ORIGINATION FORM

Proposed Revisions to a Design Standards Index
(Please provide all information – Incomplete forms will be returned)

Index Number: **17784**
Sheet Number (s): 1 of 2
Index Title: Pedestrian Detector Assembly Installation Details

Sheet 1: Changed the horizontal reach of pedestrian detector push-button to 10" (Std.) / 15" (Max.); Rearranged sheet; Updated Notes.
Sheet 2: Deleted Sheet.

SHEET
1 of 1
1 of 2

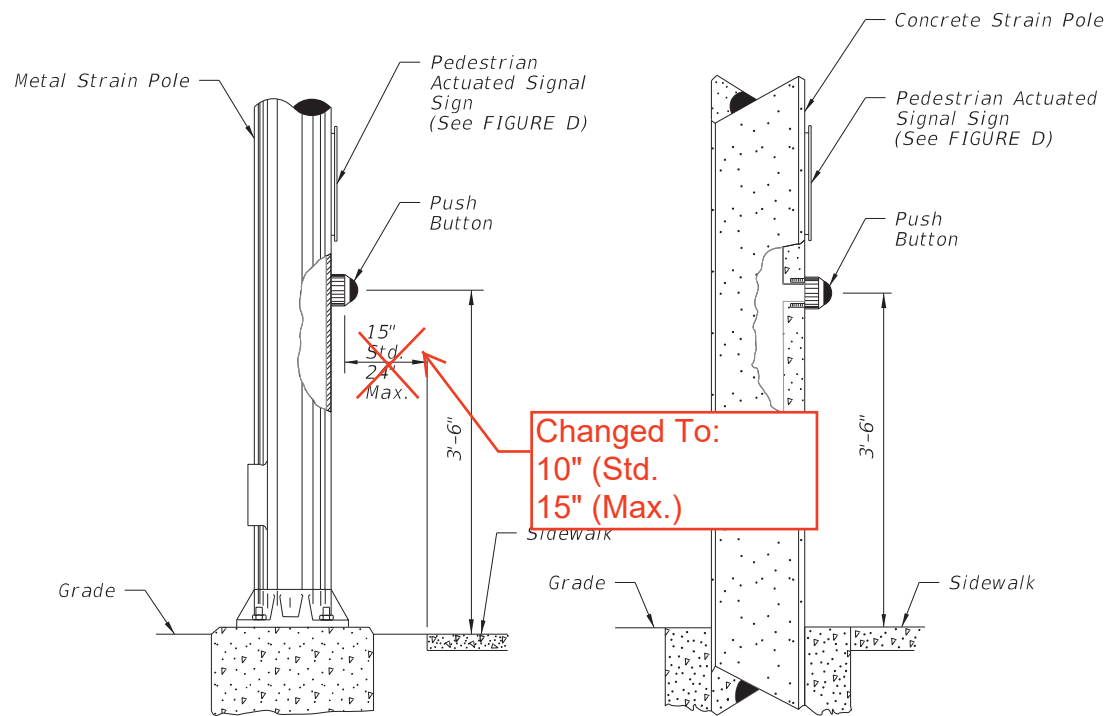
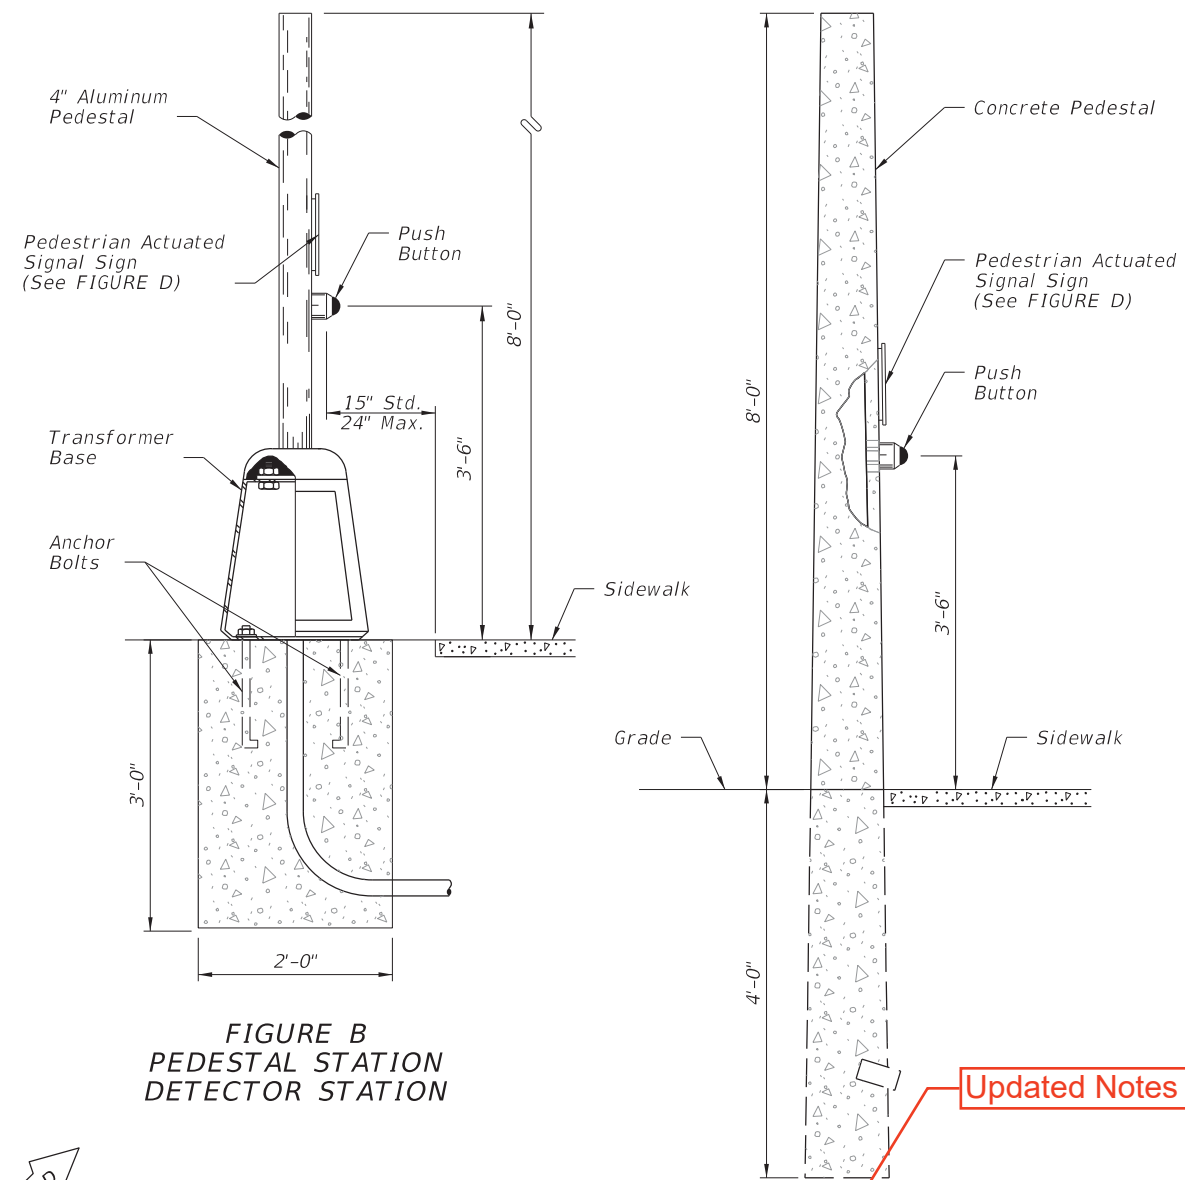
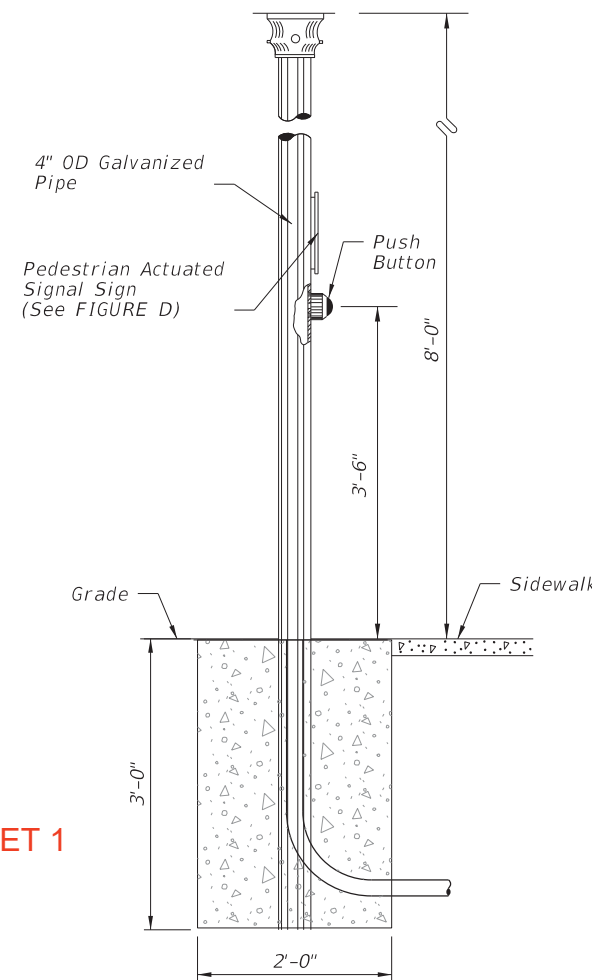
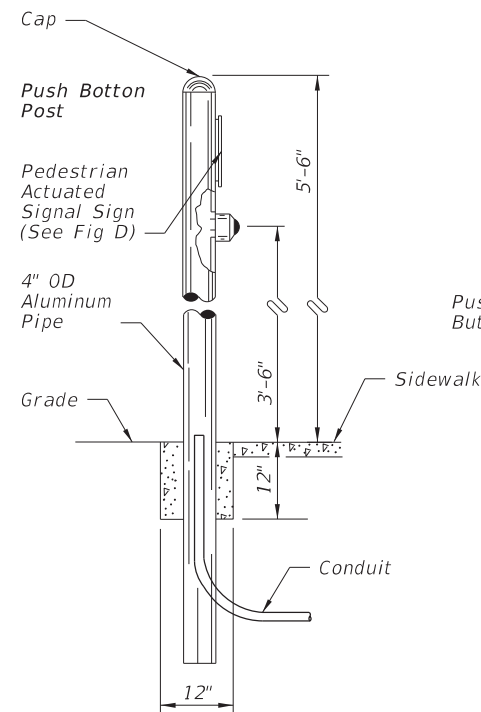
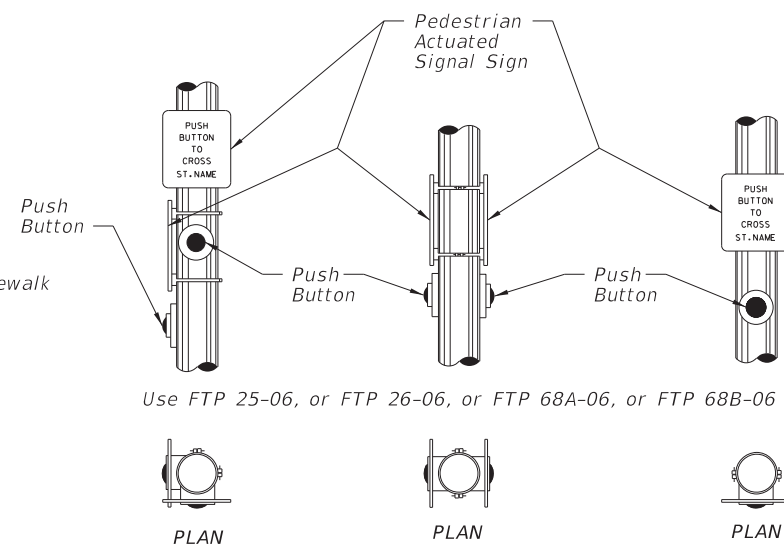
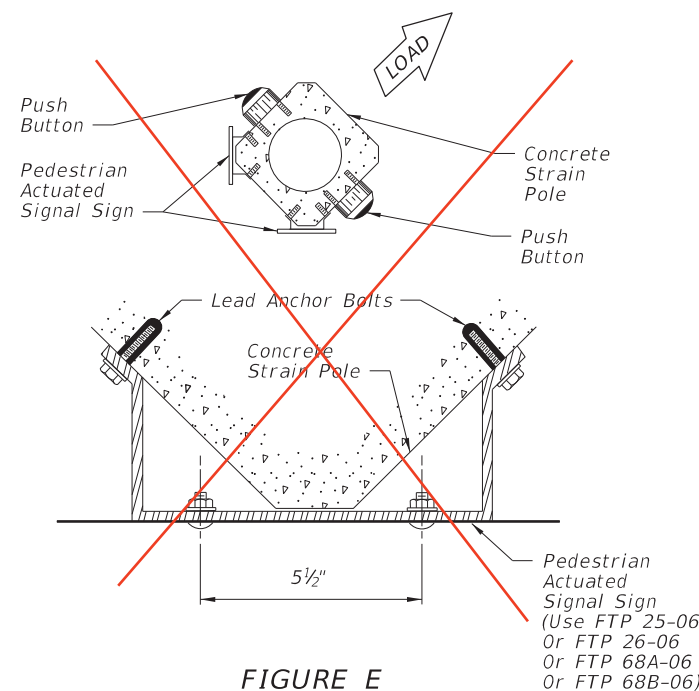
To match ADA Standards, horizontal reach to pedestrian detector (push-button) must be changed from 15" (24" max.) to 10" max. over an obstruction (i.e., guardrail) or edge of sidewalk.

REORGANIZED SHEET 1

Updated Notes

SHEET NO. 2 of 2

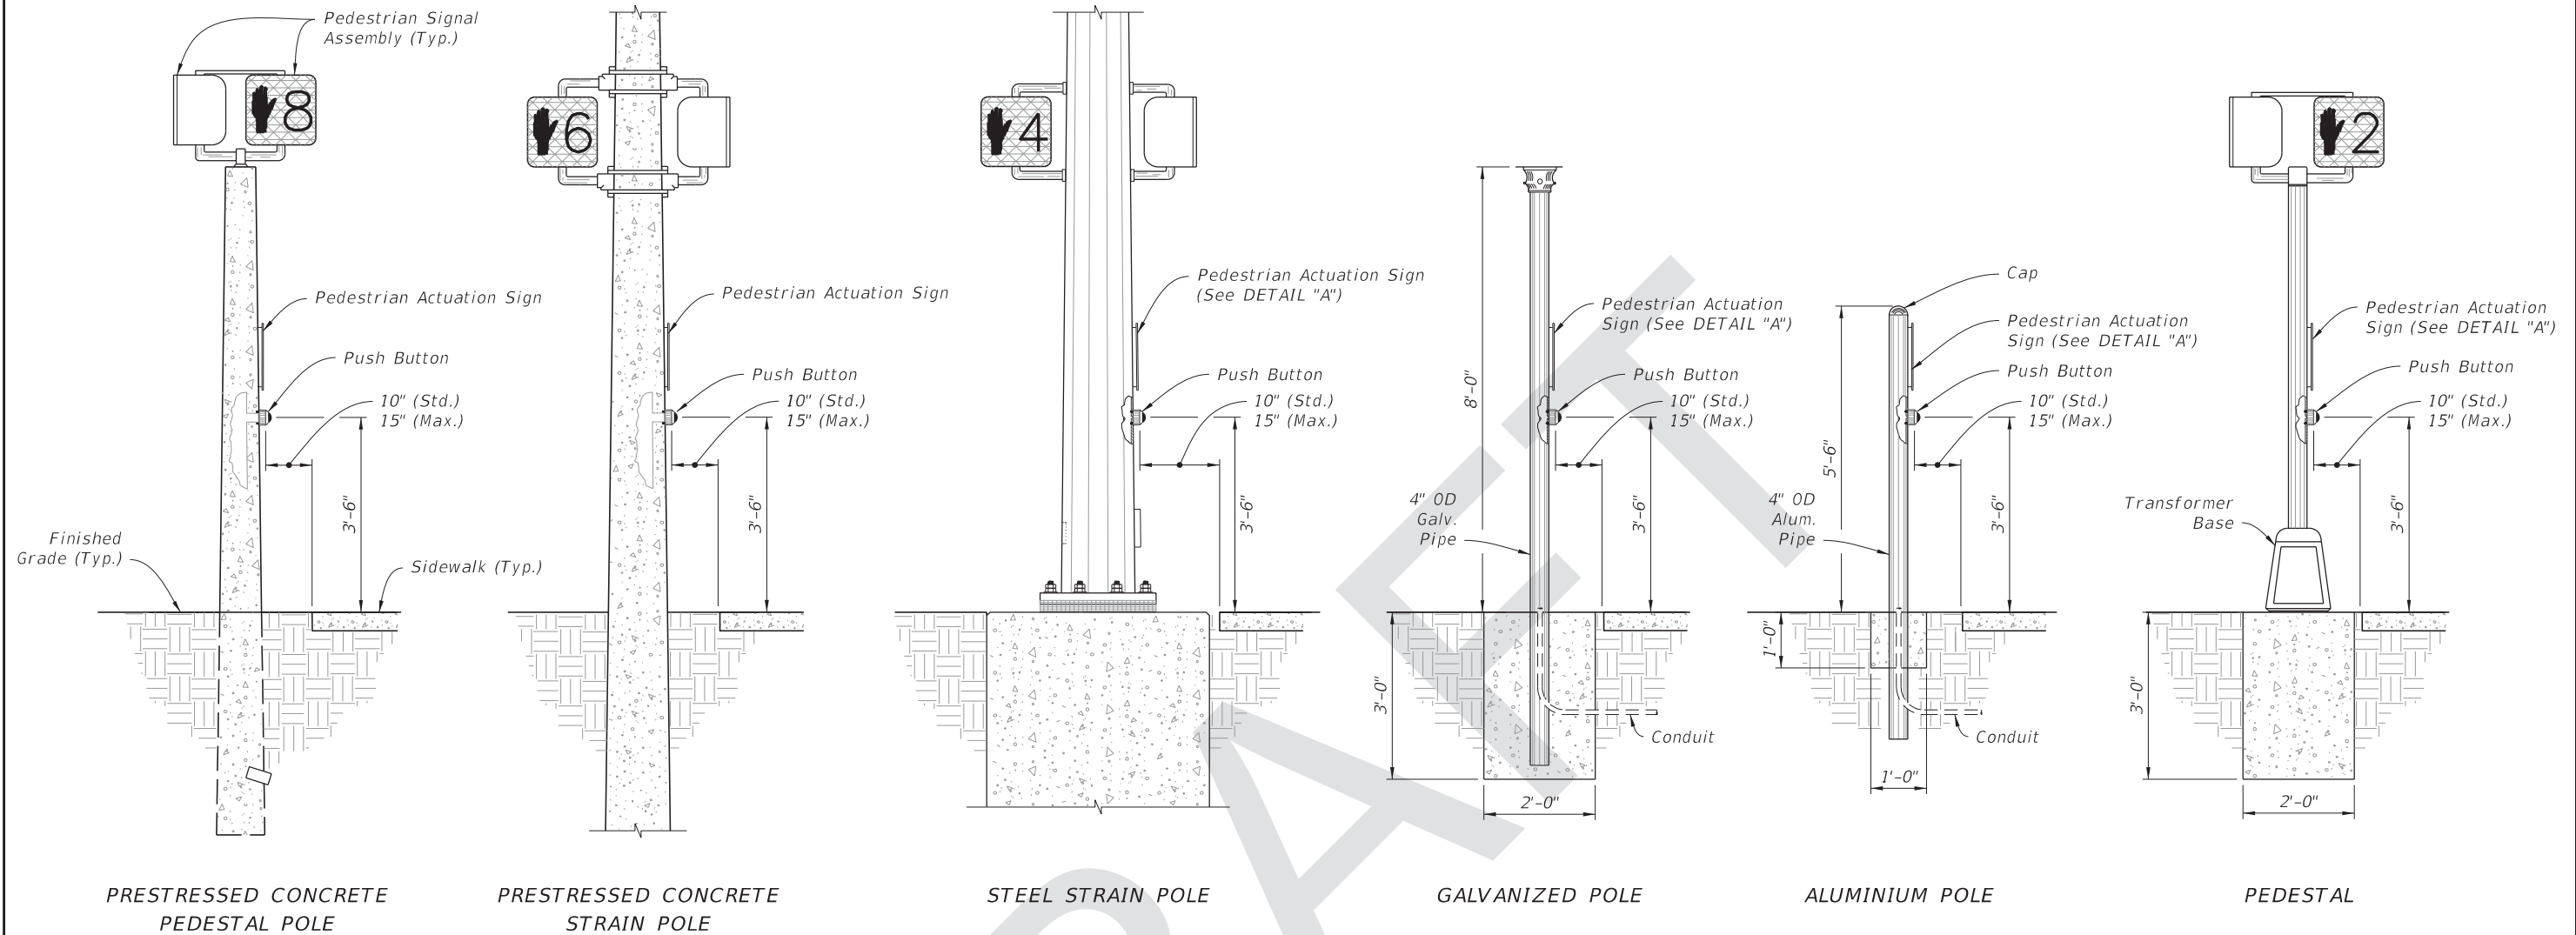
DELETED SHEET
